TRANSMITTAL OF TENTH TAAG REPORT - JBC-33-84

TENTH REPORT
OF THE
Technical Assistance and Advisory Group (TAAG)

Three Mile Island Unit 2 (TMI-2)
For the Period August 1, 1984 to December 1, 1984

TAAG COMMENTS ON CONCEPTUAL DESIGN

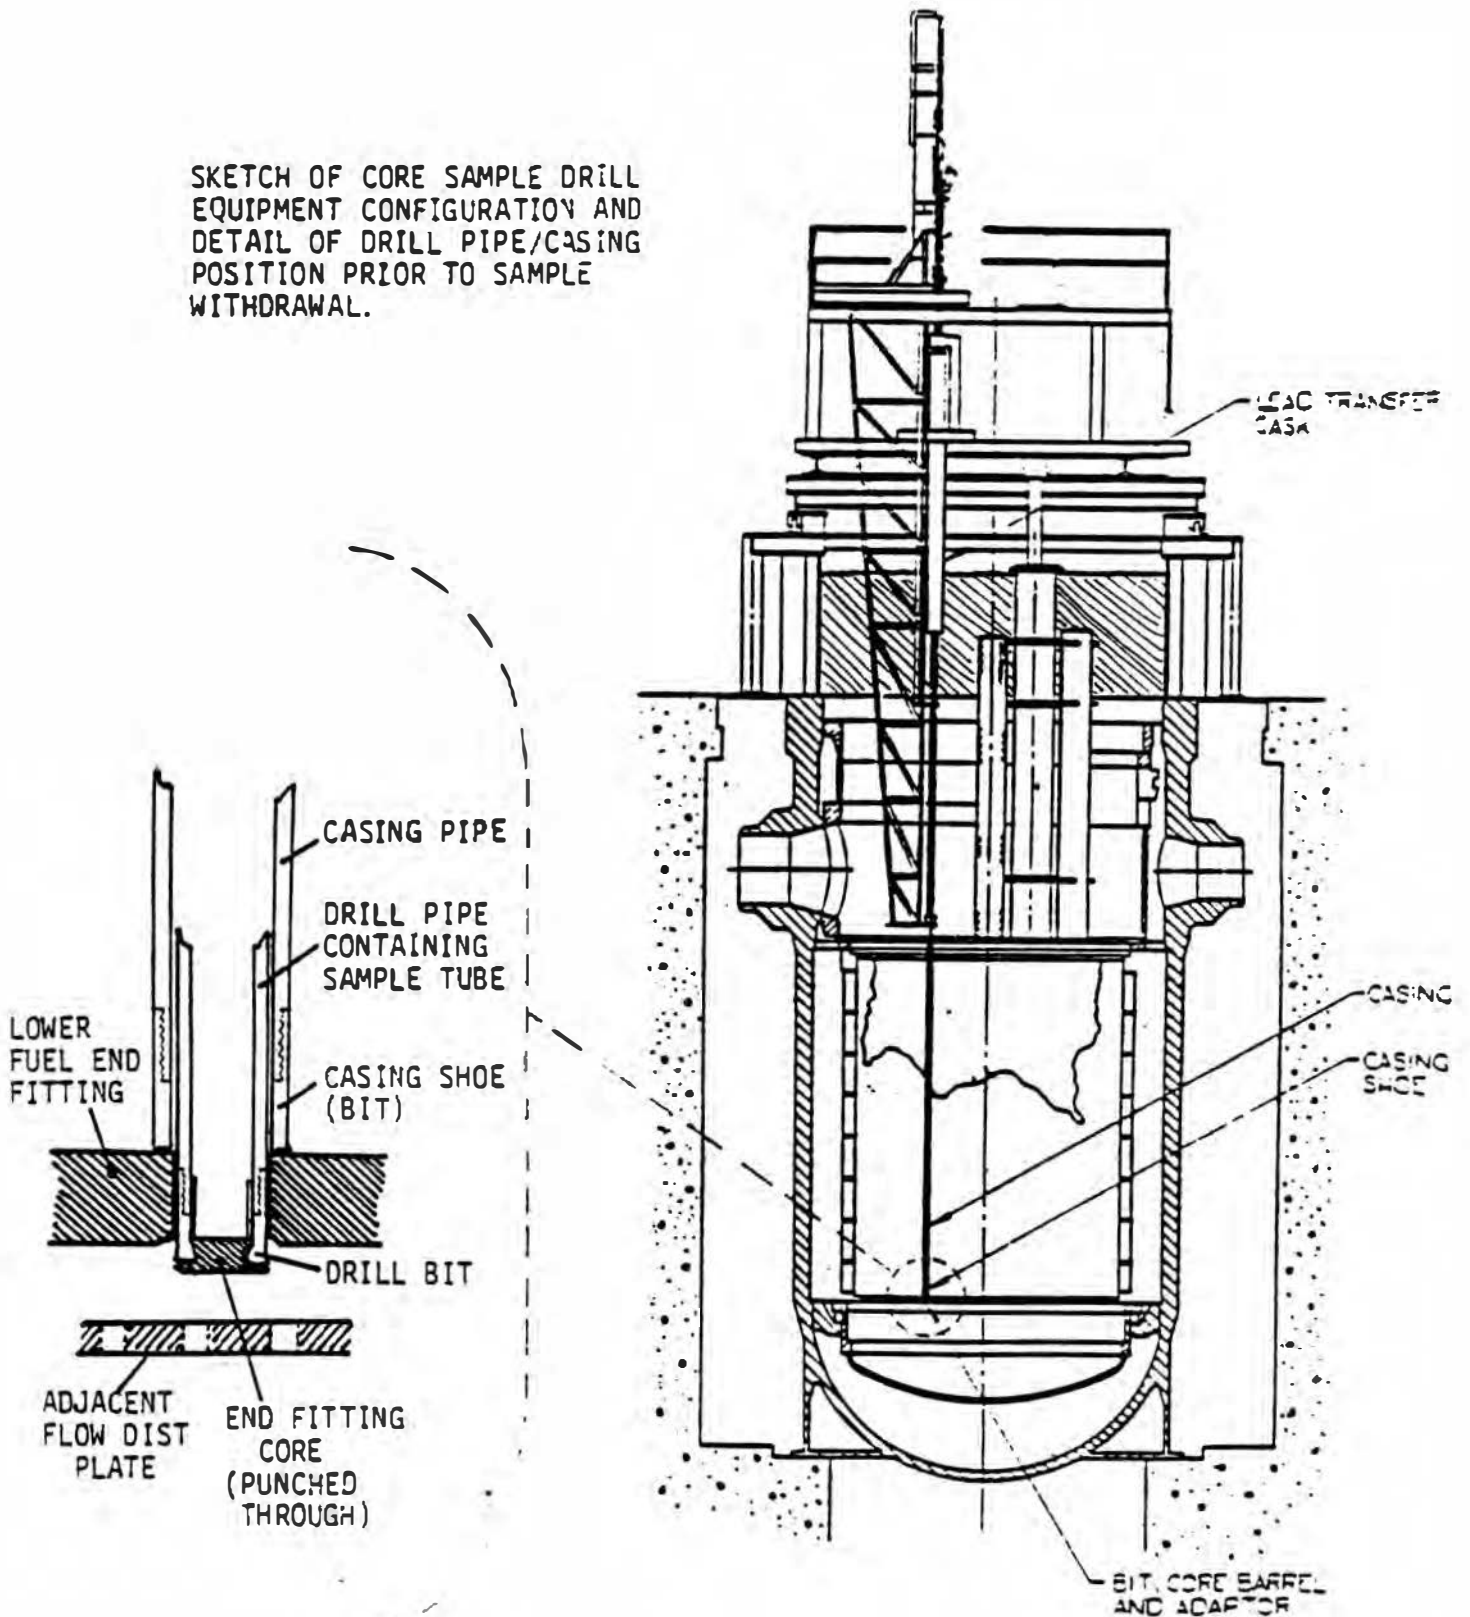
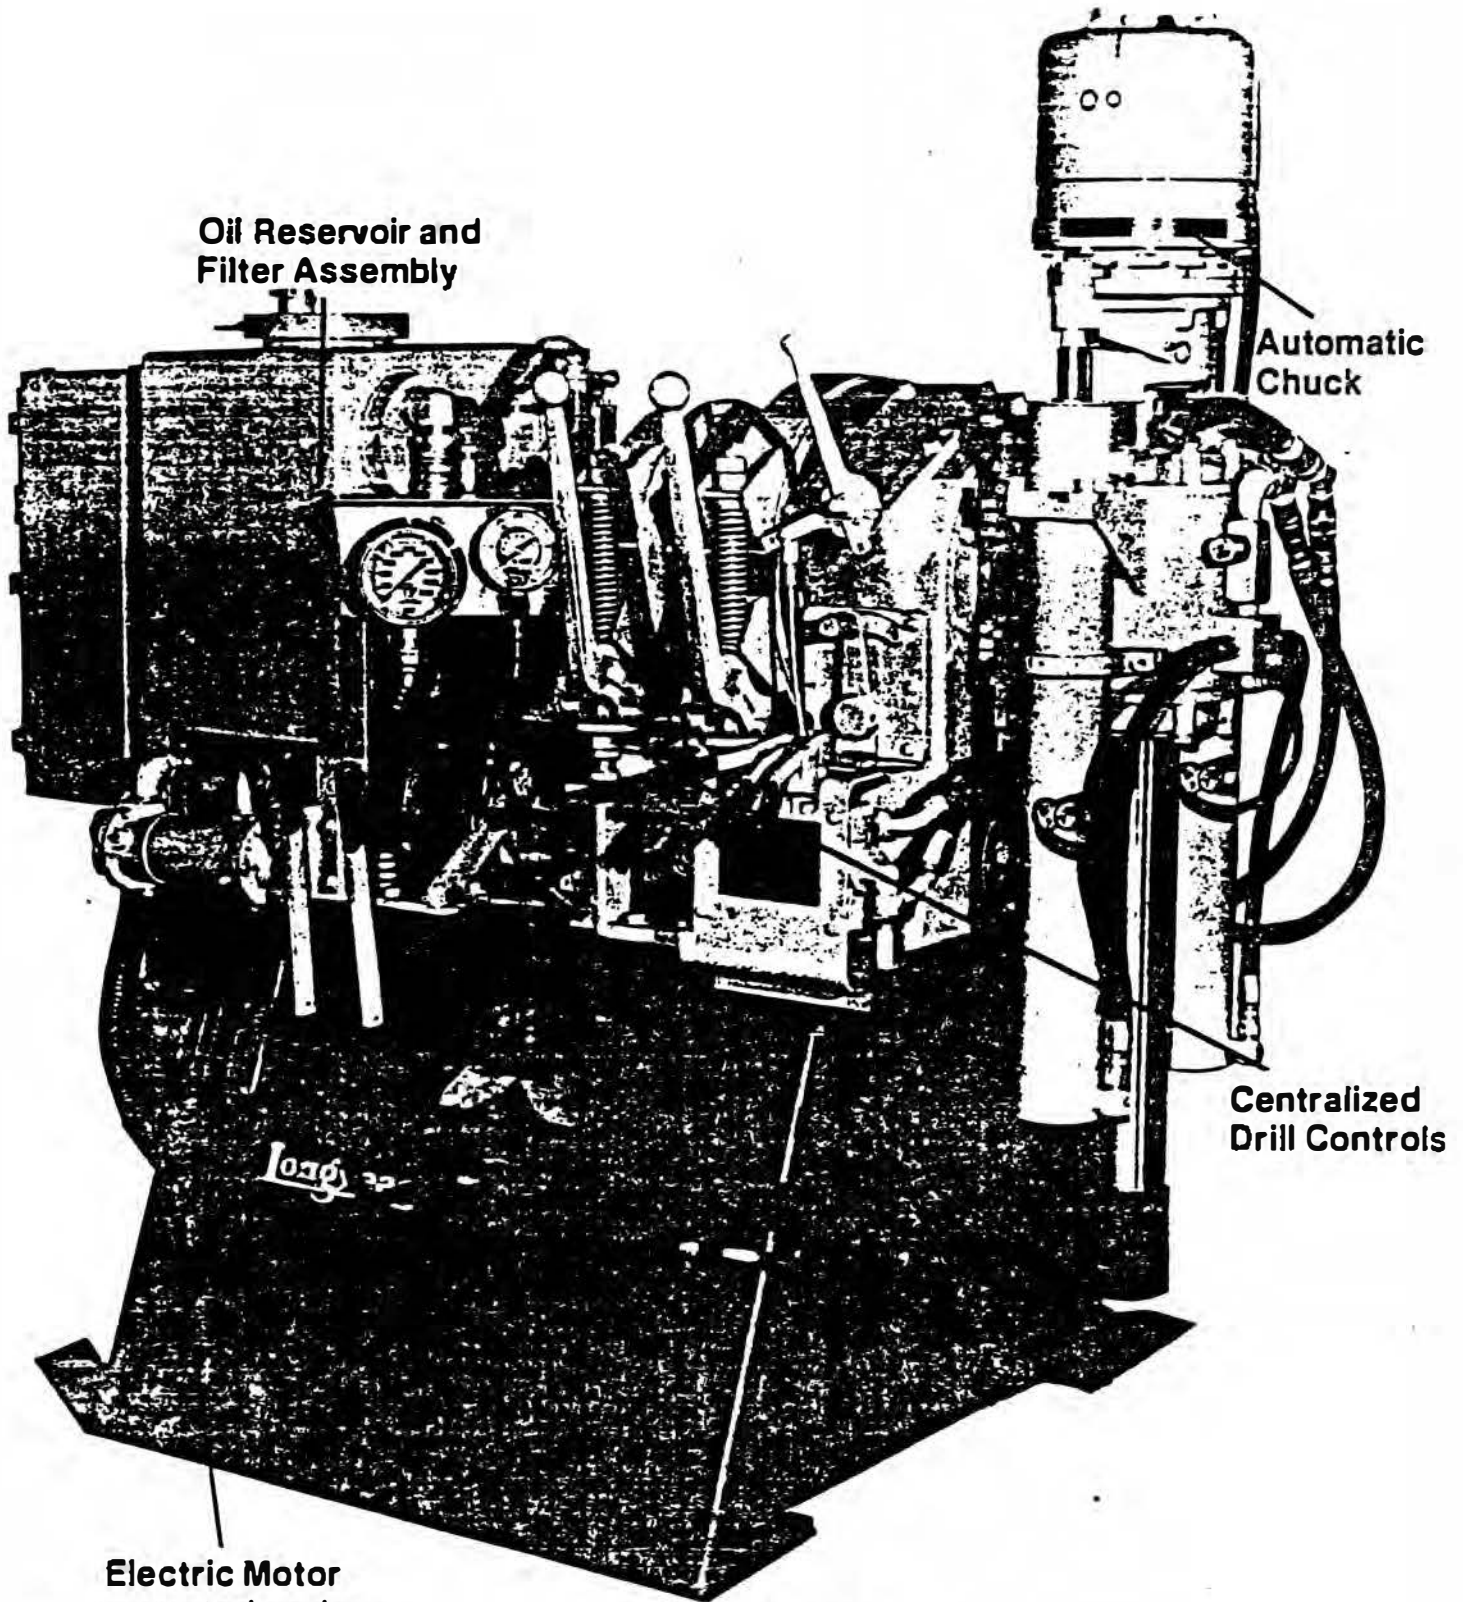
1. DESIGN ASSUMES END FITTING LOCATION HAS NOT CHANGED.
 - 0 ONCE LIQUIFIED MATERIAL SHOULD BE SUFFICIENTLY BRITTLE, IF PRESENT
 - 0 DRILL UNIT INSTRUMENTATION WILL PROVIDE FEEDBACK ON POSITION AND MATERIAL HARDNESS
2. VIBRATION CAUSED BY DRILLING OPERATION MAY RELOCATE LOOSE DEBRIS
 - 0 VIBRATION MINIMIZED BY SUPPORTING STRUCTURES BELOW WORK PLATFORM
 - 0 OTHER DEFUELING CAMERAS MAY BE AVAILABLE FOR ADDITIONAL VIDEO MONITORING
3. LOWER END FITTING PLUG MAY PREVENT REMOVAL OF CORE SAMPLE AFTER DRILLING
 - 0 PROBLEM PRECLUDED BY CASING THE DRILL PIPE AND REMOVING COMPLETE DRILL PIPE ASSEMBLY TO RETRIEVE SAMPLE

- 4. THERE ARE POTENTIAL PROBLEMS WITH DRILLING INTO UNSEEN OBJECTS WITHIN THE LOOSE DEBRIS
 - 0 CORE BORING WILL TAKE PLACE AFTER VACUUM DEFUELING
 - 0 LONG HANDLED TOOLS CAN MOVE ASIDE ANY OBJECT BEFORE DRILLING
- 5. PLANS SHOULD BE AVAILABLE TO OBTAIN LOOSE SAMPLES THROUGHOUT DEFUELING
 - 0 A SEPARATE TASK SAMPLE PACKAGE HAS BEEN SUBMITTED TO "PICK-AND-PLACE"
 - 0 CANDIDATE SAMPLES CAN BE IDENTIFIED BY VIDEO SURVEY AFTER PLENUM REMOVAL
